US-APWR DCD Revision 2 RAI Tracking Report

December 2009

This report includes a table that identifies the impact of each response to the Request for Additional Information (“RAI”) relative to the Design Control Document (“DCD”) Revision 2 of US-APWR. This table shows the RAI responses which have been submitted since October 2009 and also should be incorporated into Tracking Report and DCD in future revision.

The report also includes the DCD Markups and Revision List for the RAI responses that impacted the DCD.

Figure 12.3-1 Radiation Zones for Normal Operation/Shutdown (Sheet 11 of 34)
 Reactor Building at Elevation 76'-5"

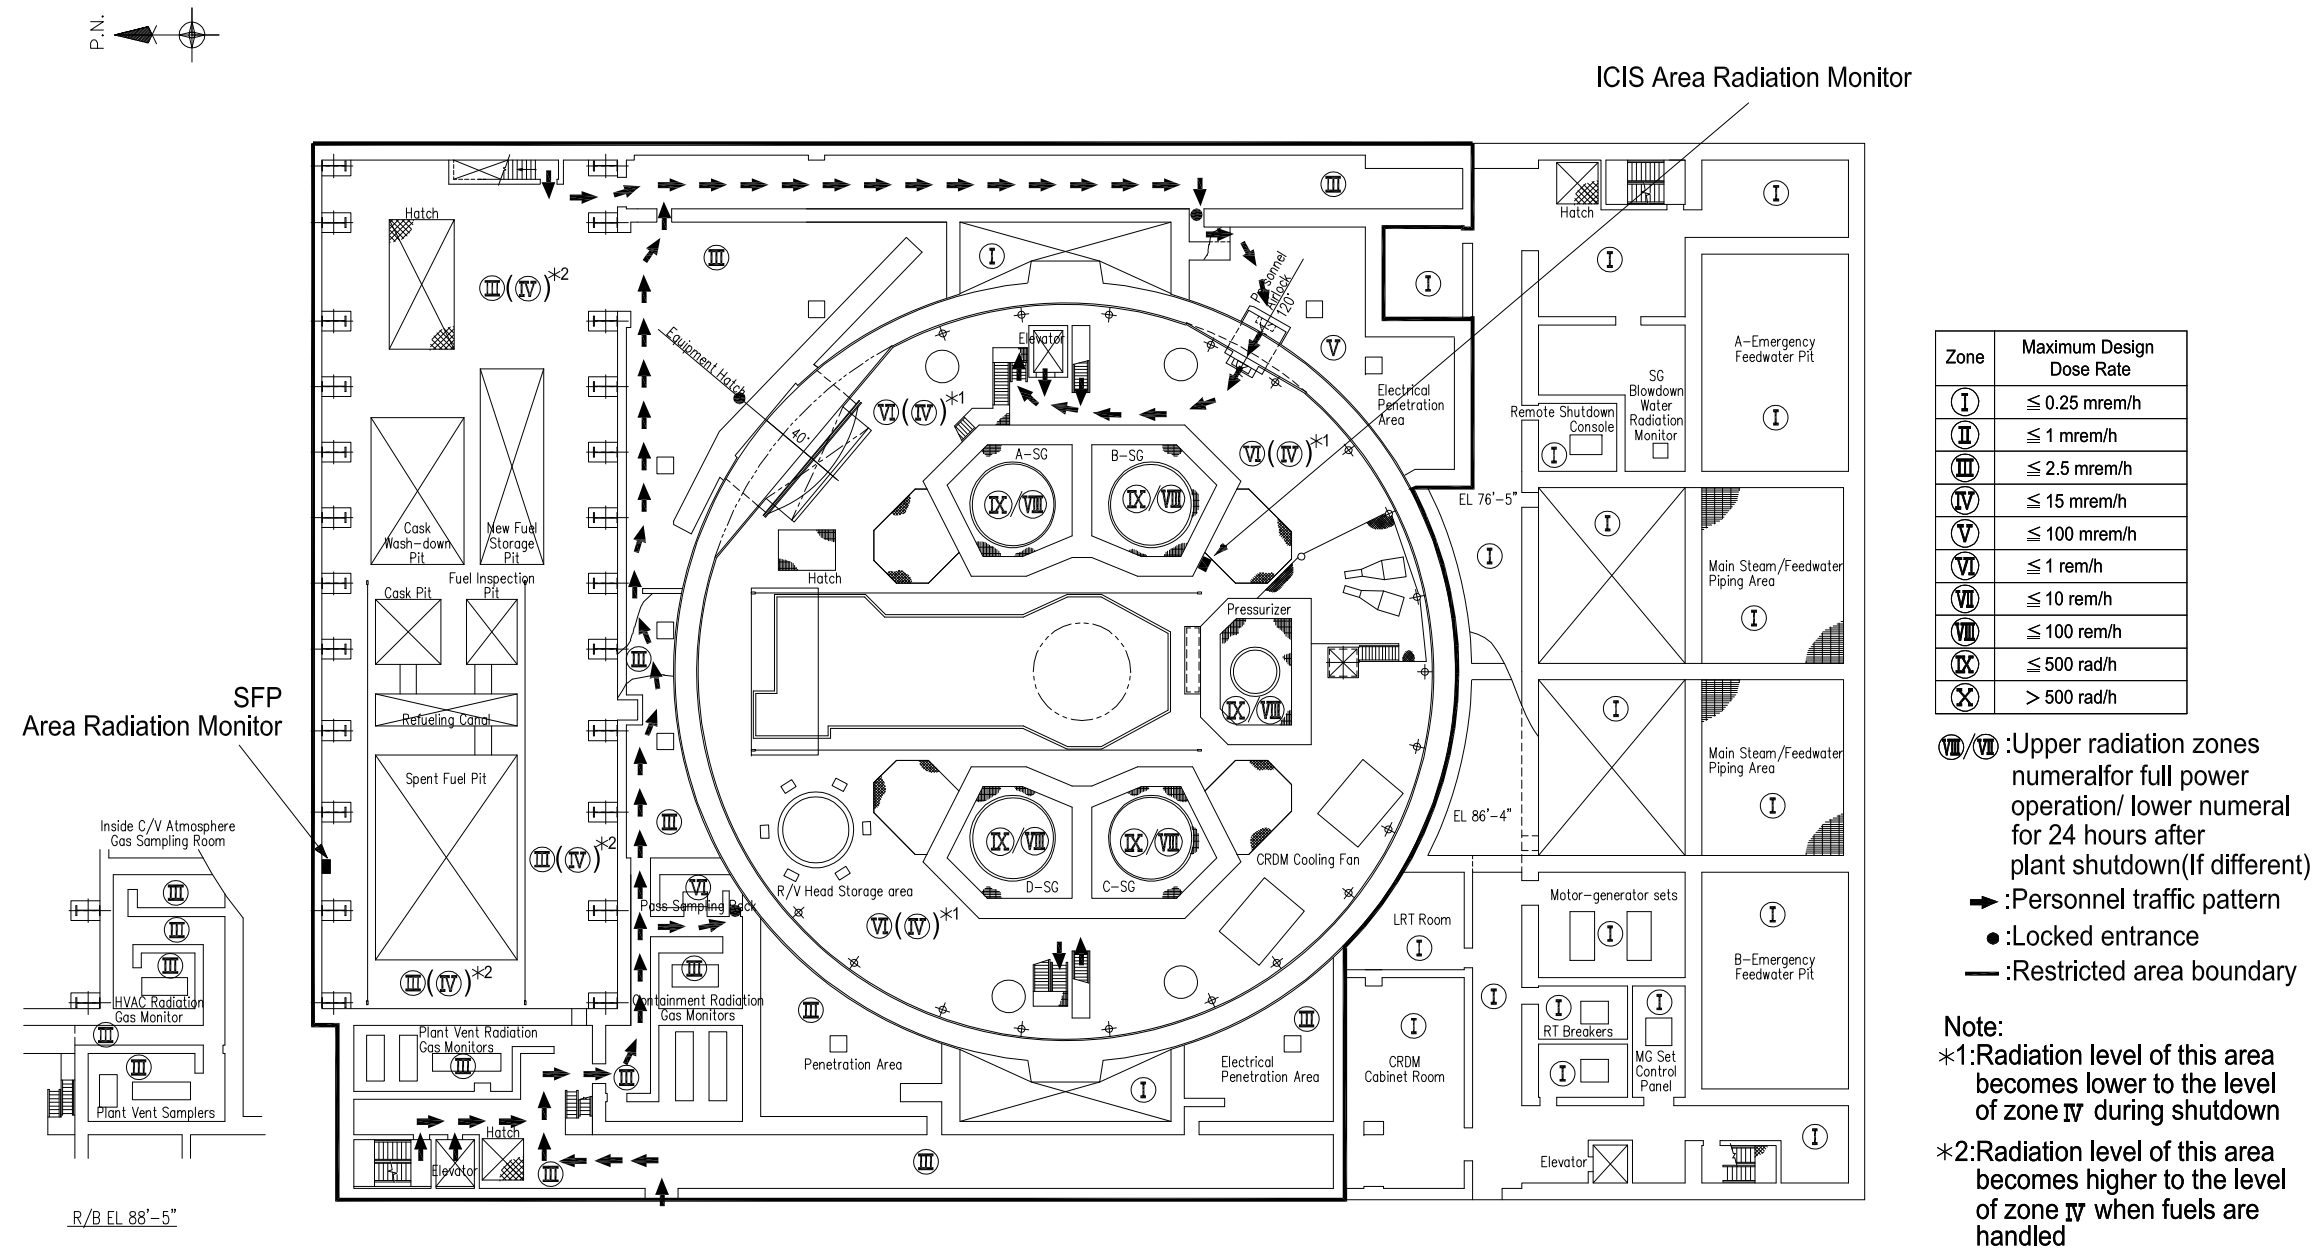
12.3-61	Figure 12.3-1 (Sheet 11 of 34)	Moved the location of the ICIS Area Radiation Monitor. RAI No.429-3178 Revision 1

Figure 19.1- 20 Loss of Offsite Power Event Tree

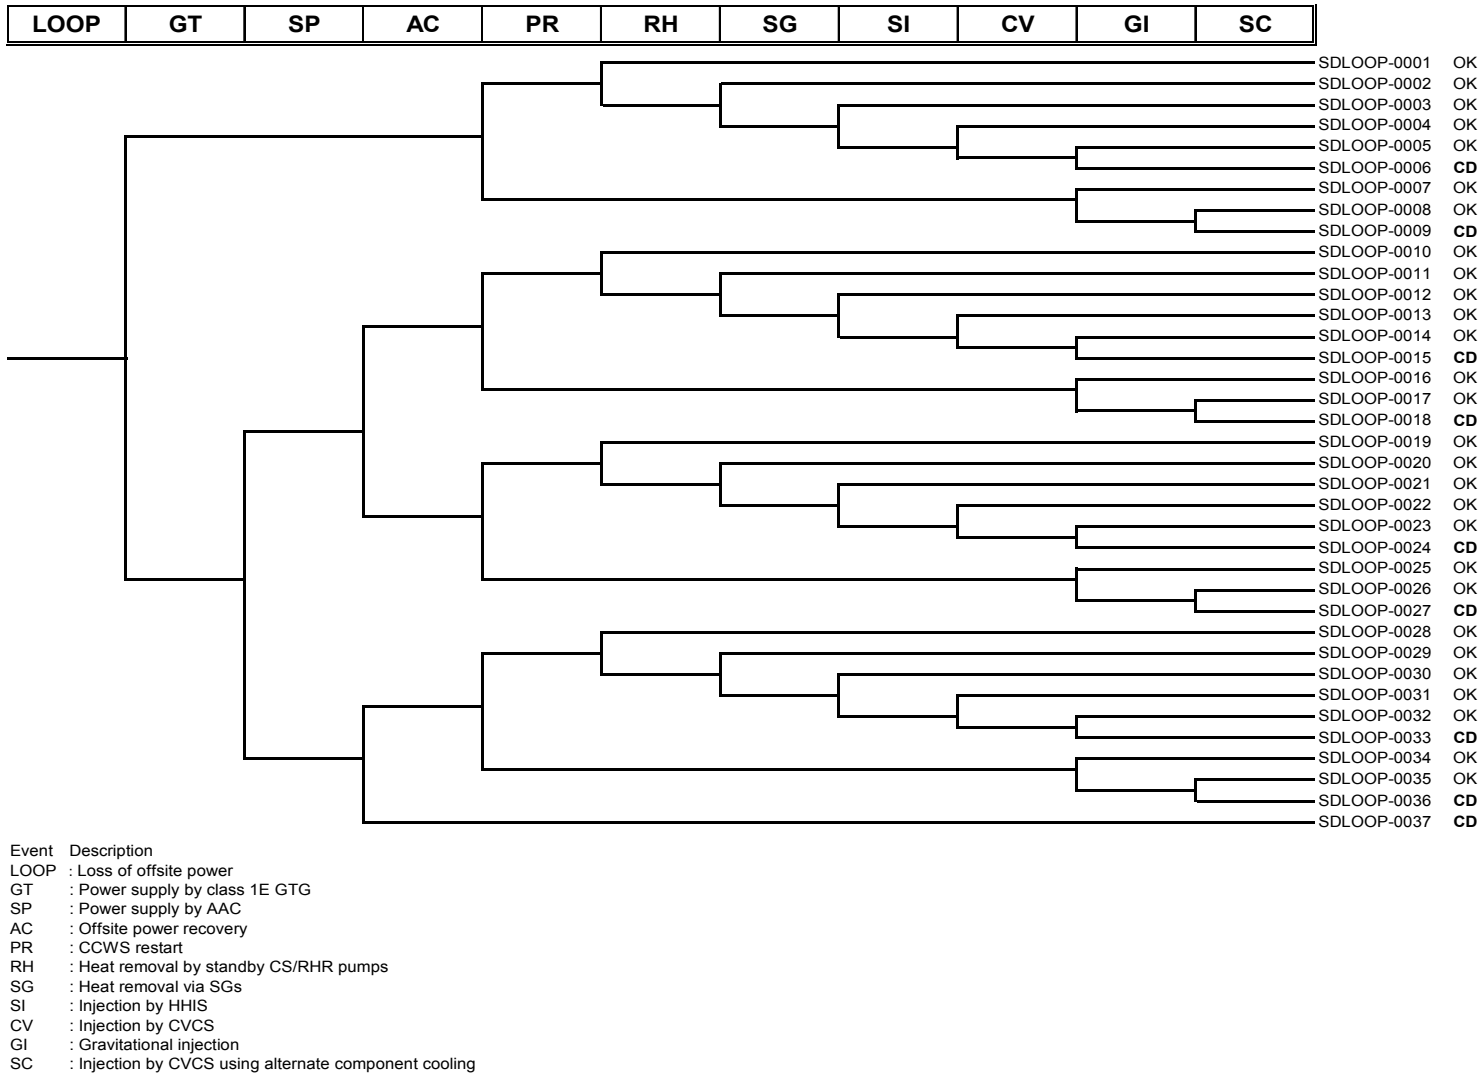
19.1-1049	Figure 19.1-20	RAI#39 19-68 Changed the loss of offsite power event tree figure to the one that has been revised associated with change in loss of offsite power initiating event frequency.
